# **Final Environmental Statement**

related to the operation of  
**WPPSS Nuclear Project No. 3**

Docket No. 50-508

Office of Nuclear Reactor Regulation

Figure 4.1 Site layout

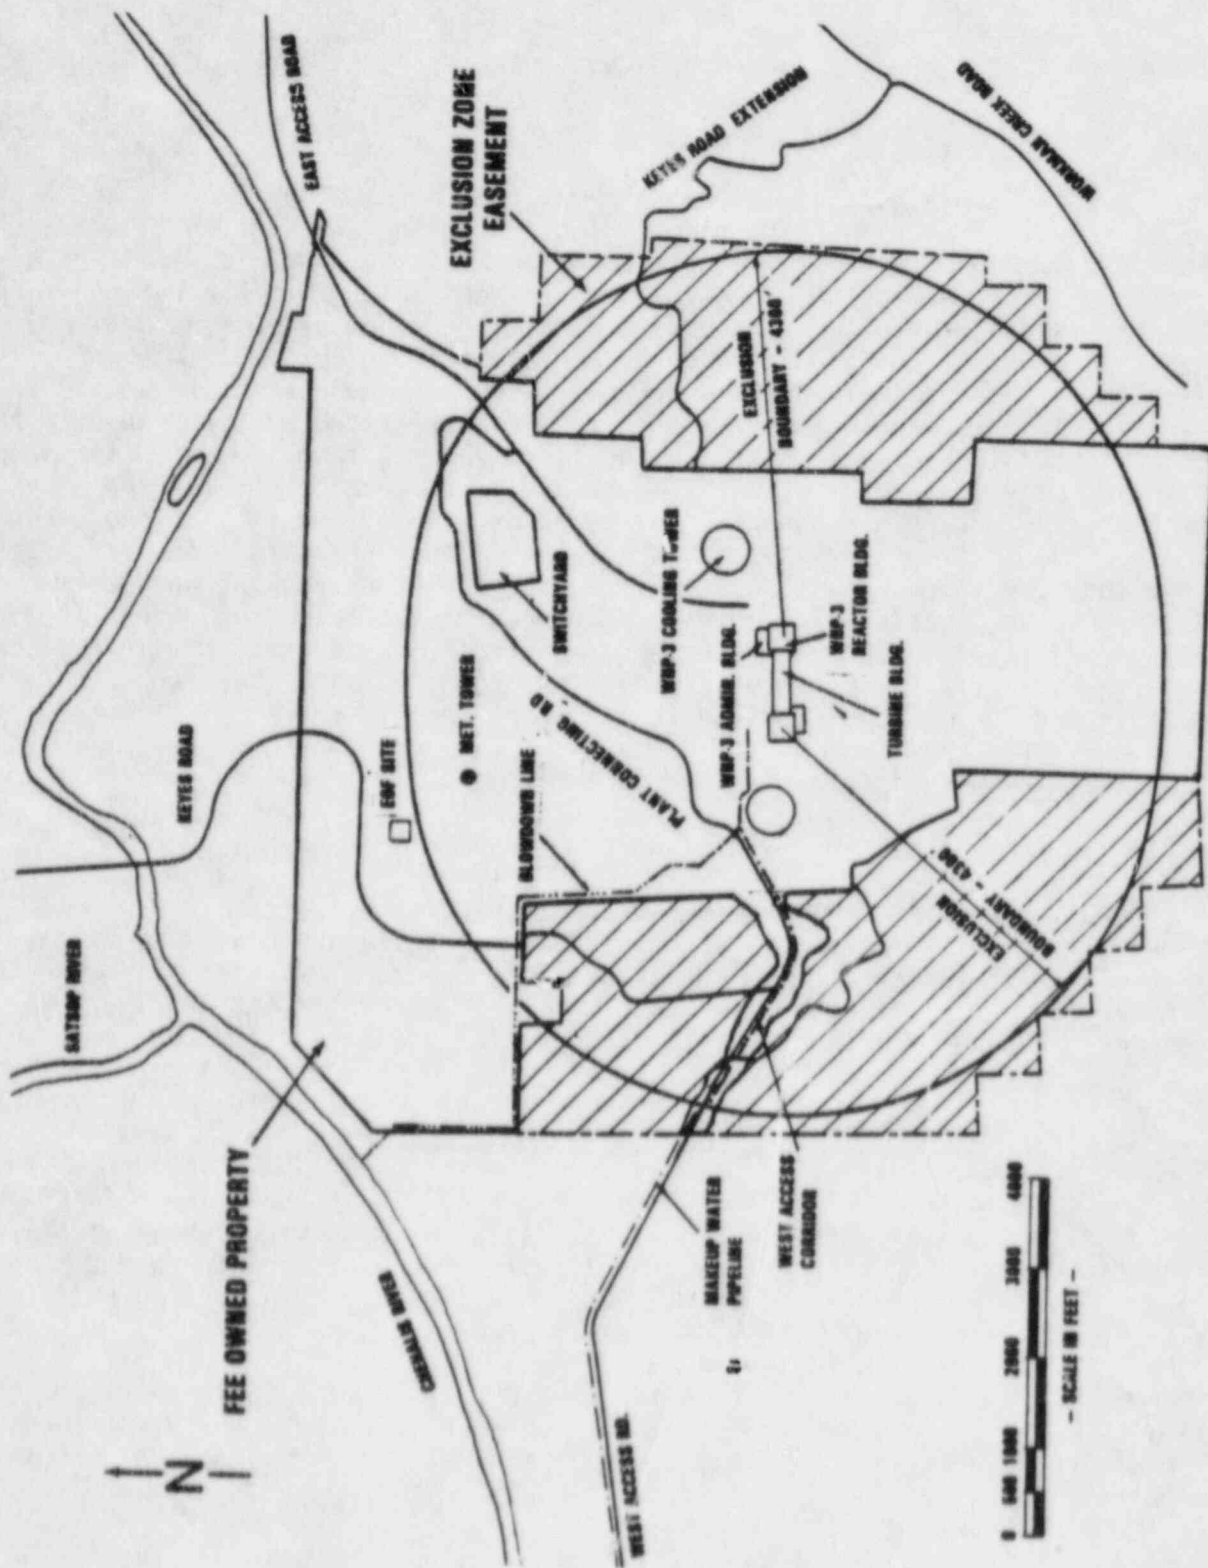
WPPSS\* notes that Figure 4.1 (ER-OL Figure 2.1-1) is to be amended.

ECOL notes that the site layout (Figure 4.1) shows the Keyes Road Extension on the east of the plant and into the exclusion zone. A significant section of this road is not shown--the portion that extends from near the No. 3 cooling tower, past the turbine generator, and connecting with the main Keyes Road terminus at the top of Fuller Hill. ECOL says this road is significant as an alternative access to the site and/or evacuation corridor, and that there has been some discussion of eliminating use of this road in favor of diverting any required cross traffic to the plant connecting road. ECOL notes that use of either or both could have impacts on plant security and emergency response plans, and should be discussed in the FES.

Figure 4.1 is taken from ER-OL Figure 2.1-1 which will be amended consistent with the response to Q290.14 and the acreages cited in DES-OL Section 4.2.2. FSAR Figure 2.1-1 has already been amended (December 1983). Also note in Section 4.2.1 that reduction of the base diameter of the cooling tower by 90 feet is not an exception to conclusions regarding the significance of changes in the arrangement of site structures. Construction laydown area should be added to the list at the bottom of p. 4-1.

Figure 4.1 (page 4-2): The site layout map indicates the Keyes Road extension to the east of the plant and into the exclusion zone. A significant section of this road is not shown--the portion that extends from near the No. 3 cooling tower, past the turbine generator, and connecting with the main Keyes Road terminus at the top of Fuller Hill. It is significant as an alternative access to the site and/or evacuation corridor. There has been some discussion of eliminating use of this road in the future in favor of diverting any required cross traffic to the plant connecting road. Use of either or both could have impacts on plant security and emergency response plans, and should be discussed in the DEIS.

A revised version of the figure is included in the FES (see Figure 4.1).

The applicant intends to abandon the segment of Keyes Road extension within the site and control access to the exclusion zone easement area via Keyes Road; therefore, omission of the on-site segment of Keyes Road from Figure 4.1 is appropriate. A full review of emergency response plans is provided for by 10 CFR 50.47 and 10 CFR 50, Appendix E, and the staff findings will be reported in the SER.

Figure 5.1 100-year floodplain

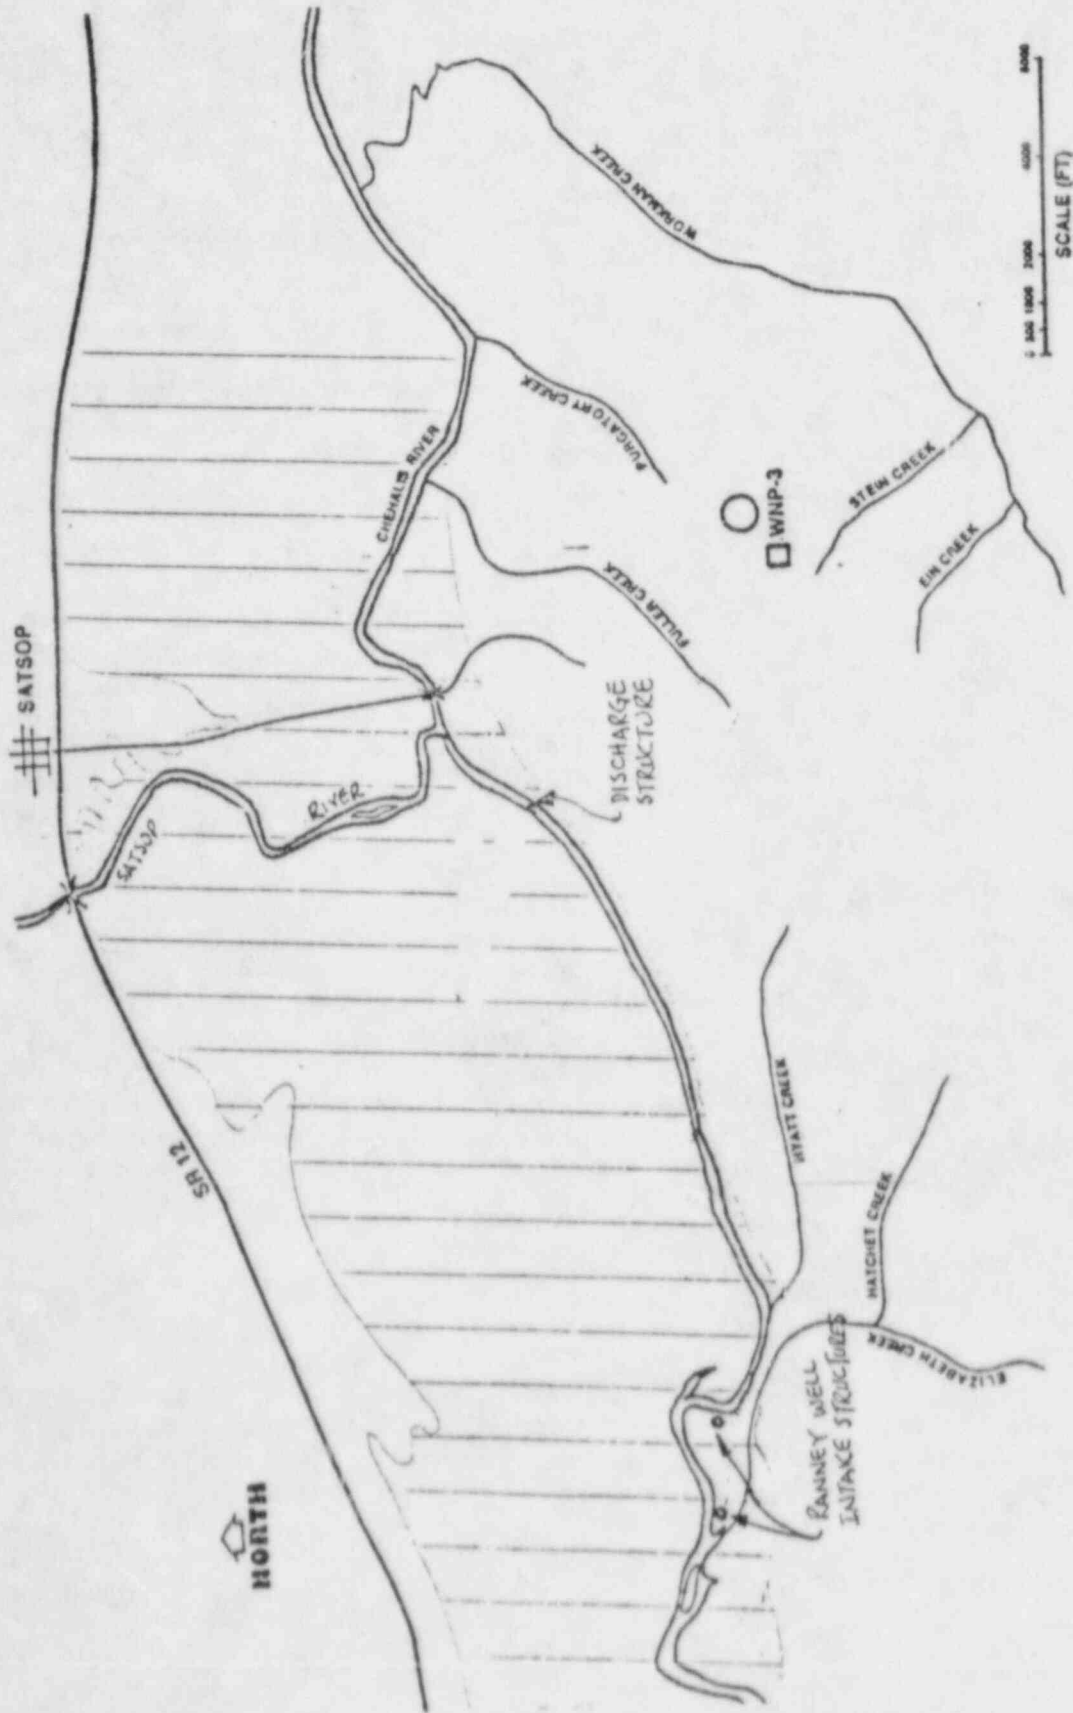
referred to as Stein Creek (see Figure 5.1). Workman Creek is not an ephemeral stream. WPPSS also suggests that the eighth paragraph is out of place.

In the second and fourth paragraphs on p. 5-51 (the third seems out of place), it should be noted that the plant underdrains discharge to a Workman Creek tributary which is referred to as Stein Creek (see Figure 5.1). Workman Creek is not an ephemeral stream. Also, we note that the third paragraph on p. 5-56 seems misplaced and perhaps belongs to the discussion of uncertainties on p. 5-63.

Figure 5.6 Probability distribution of early fatalities. See Section 5.9.4.5(7) for a discussion of uncertainties in risk estimates; also see footnote in Section 5.9.4.5(3) for help in interpreting this figure. (10 mi = 16 km)

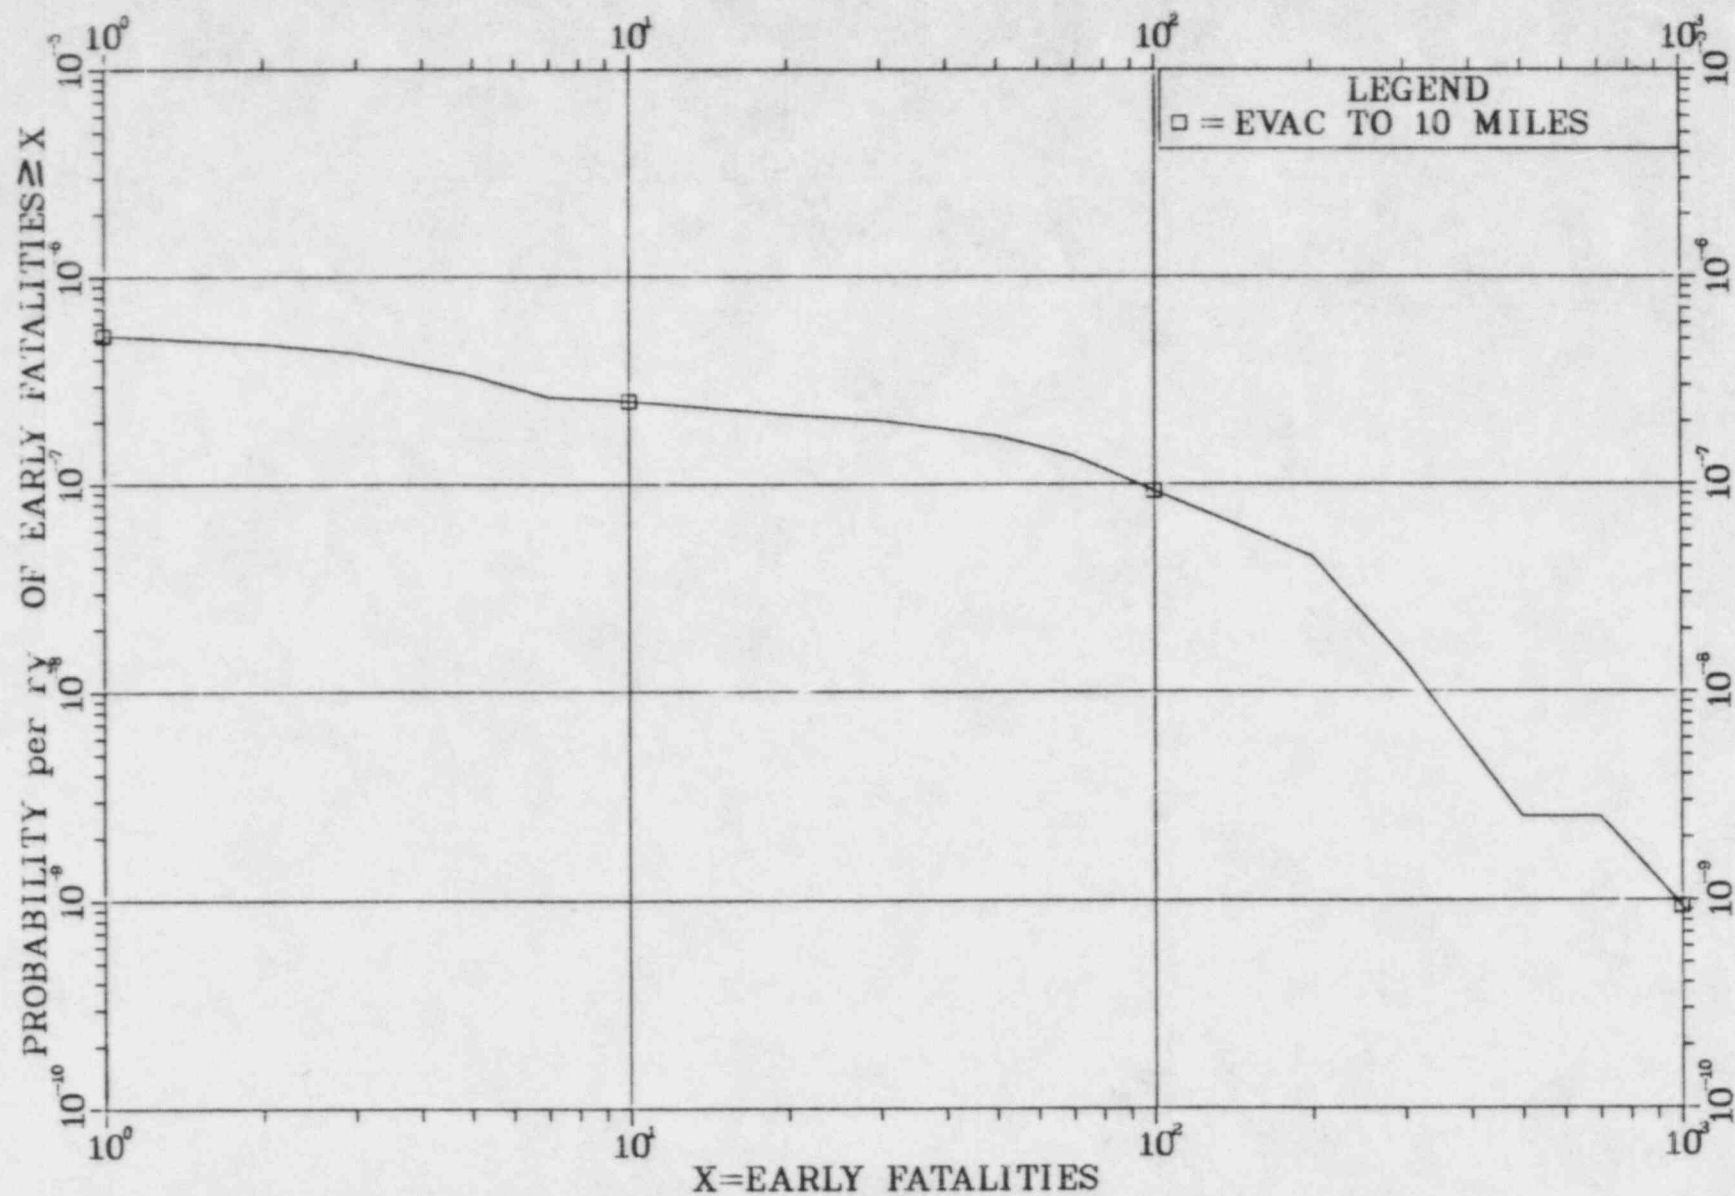
WPPSS notes that the figure references given in Table 5.7 are not correct, and that the radius cited in the discussion on Figure 5.6 should be 28-km. WPPSS also states that, to be consistent with Appendix D, the annual average population dose within 80 km of WNP-3 from natural background radiation should be 82,000 person-rems.

Figure 5.11 Isopleths of risk of latent cancer fatality per ry to an individual  
(10 mi = 16 km,  $5\text{E-}10 = 5 \times 10^{-10}$ )

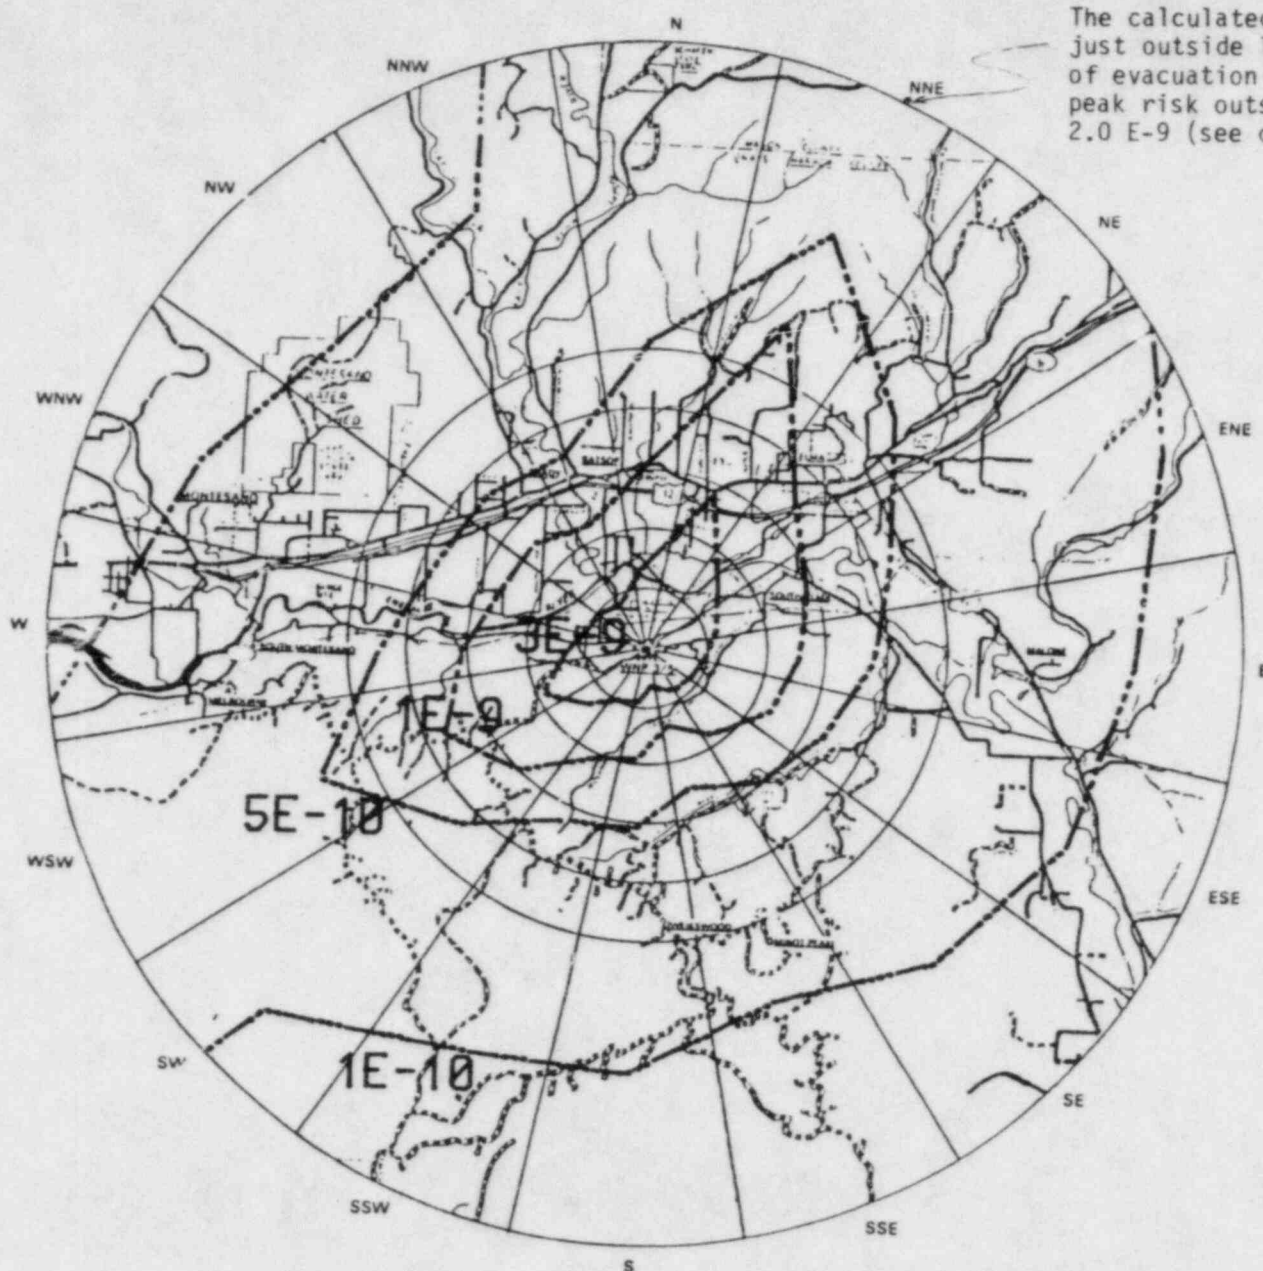
WPPSS notes that the figure referenced in the discussion on latent cancer fatality risk should be Figure 5.11.

- WPPSS-38 On p. 5-53, at the bottom, Figure 5.9 should be Figure 5.11.
- WPPSS-39 On p. 5-43 incorrect figure references are given in Table 5.7. In the second paragraph on this page the background radiation dose should be 82,000 person-rems consistent with p. D-9. Also, at the bottom of the page "28-m" should be "28-km."
